WATER GETTING IN YOUR GAS TANK?

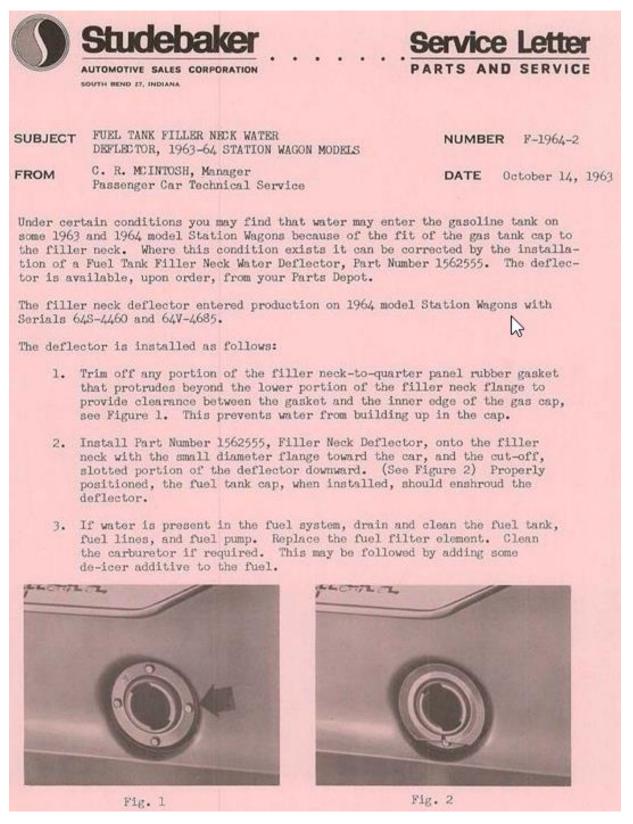
Prior to production models starting with serial numbers 64S-4460 and 64V-4685 some 1963 and 1964 Wagonaires experienced a problem with water being allowed into the gas tank through the filler neck to body panel connection. A modification which became available in October 1963 can be installed to do away with that problem. Here is the Studebaker Service Letter issued about the modification:
